Product Change Notice (PCN)

PCN Number: PCN-0450001R-01

Product(s) Affected:
SJ-3501-SMT-TR

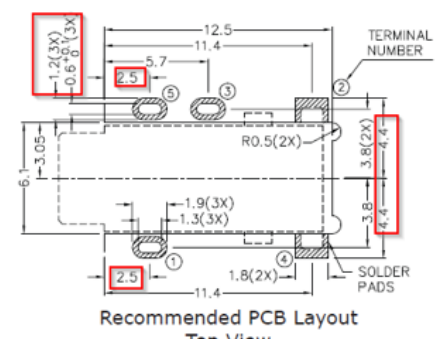
Description of Change:

1. Slight terminal spacing difference 0.1mm higher
